Office Action Summary

10/724,812

OKADA, TSUTOMU

DETAILED ACTION

Annotated Fig. 1 of Chu (5,968,056)

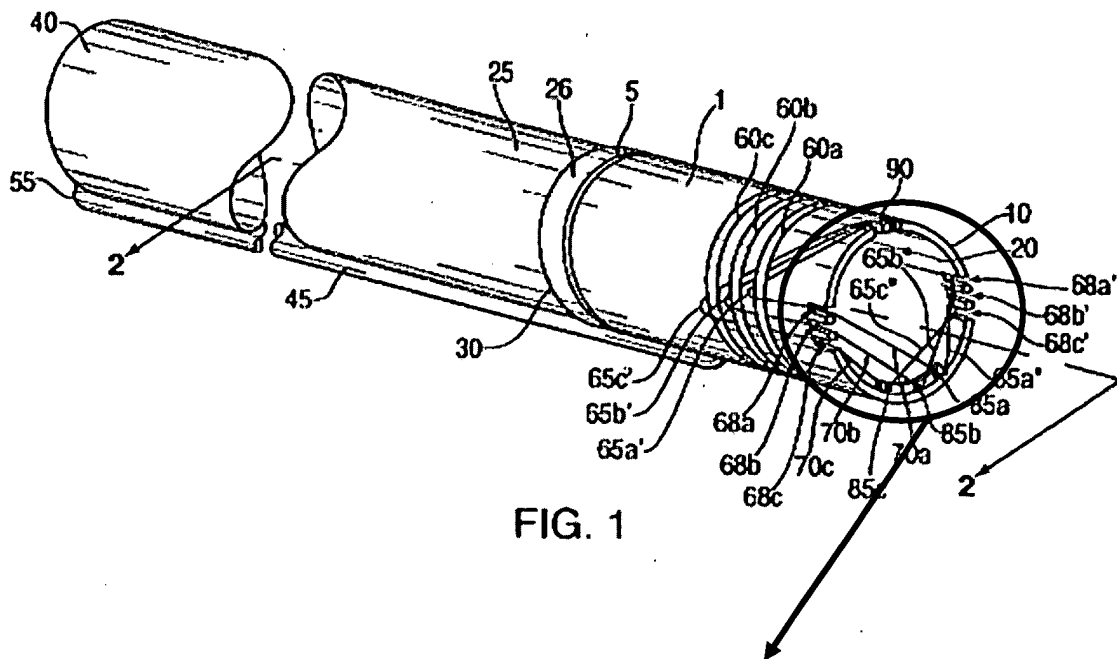
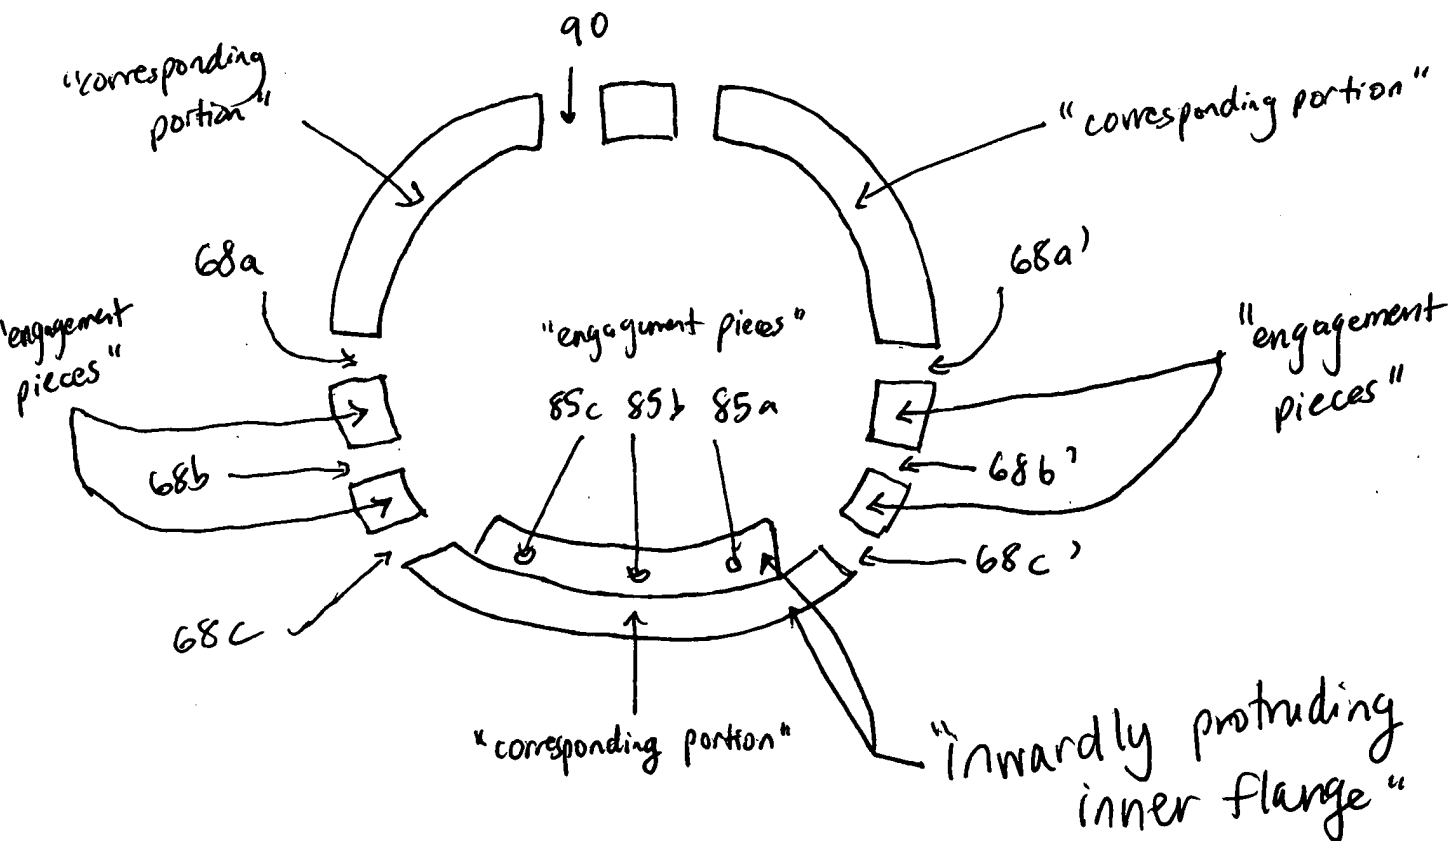
Claims 1, 3-6, 9-10, and 13-15: Chu discloses a substantially cylindrical cap **1** including a cylindrical wall and having a circular end portion including a holding mechanism which holds a distal end portion of a snare wire **70** in a loop form in an inner portion of the cylindrical wall, and an attachment portion **5** which attaches the cap to an end portion of an endoscope **25**, wherein the holding mechanism has a plurality of engagement pieces (adjacent to **90**, **68a-c**, **68a'-c'**) and a plurality of corresponding portions (in between **68a-c** and **90**, and **90** and **68a'-c'**) which hold the distal end portion of the snare wire between the engagement piece and the corresponding portion, said plurality of engagement pieces and being respectively distanced from each other in a circumferential direction of the circular end portion, and each of the engagement pieces is sectioned from the corresponding portion by a pair of vertical notches

90, 68a-c, 68a'-c' which are distanced at the circular end portion in the circumferential direction and formed at a substantially right angle with the circumferential direction - in that they possess a width (Figure 1 (Figures 1 and 4)). Chu also discloses the plurality of engagement pieces (adjacent 68a-c and 90, and 90 and 68a'-c') being arranged in the same interval in the circumferential direction and each of the engagement pieces and each of the corresponding portions (in between 68a-c and 90, and 90 and 68a'-c') directly contact opposite sides of the end portion of the snare wire to hold the end portion therebetween (Figure 1).

Chu discloses the inner flange (at distal end of **10**) having a plurality of lateral notches **90, 68a-c, 68a'-c'** extending in the circumferential direction, and each said pair of vertical notches extend toward the cylindrical wall from both ends of each lateral notch (Figure 1).

Chu discloses the circular end portion having a plurality of lateral notches extending in the circumferential direction between the inner flange and the cylindrical wall, and each said pair of vertical notches **90, 68a-c, 68a'-c'** extend toward the cylindrical wall from both ends of each lateral notch (Figure 1).

Chu discloses the corresponding portion (in between **68a-c** and **90**, and **90** and **68a'-c'**) having a flange provided so as to inwardly protrude from the cylindrical wall, the engagement piece (adjacent **90, 68a-c, 68a'-c'**) having separation portions separated from each other by a notch portion formed in the inner flange, and the snare wire is supported between the flange and the separation portions (Figure 1).

Chu discloses the engagement pieces and the corresponding portions in between **68a-c** and **90**, and **90** and **68a'-c'**) being alternately arranged in the circumferential direction of the circular end portion (Figure 1).

Chu discloses the claimed device except for the engagement pieces (adjacent to **90**, **68a-c**, **68a'-c'**) being inwardly protruding from the cylindrical wall. However, Chu discloses engagement pieces (ports **85a-c**) being formed in the inner flange of the cylindrical wall, or inwardly protruding from the cylindrical wall so as to inwardly protrude from the end portion of the wall (Figure 1). It would have been obvious to modify the notches **90**, **68a-c**, **68a'-c'** and engagement pieces adjacent to **90**, **68a-c**, **68a'-c'** to also be protruding in order to facilitate a more secure engagement of the distal end portion of the snare wire and it was well known in the art that flanges or lips having coupling portions that extend axially into a distal circular end portion provides an abutment wall that effectively prevents disengagement of a snare wire.
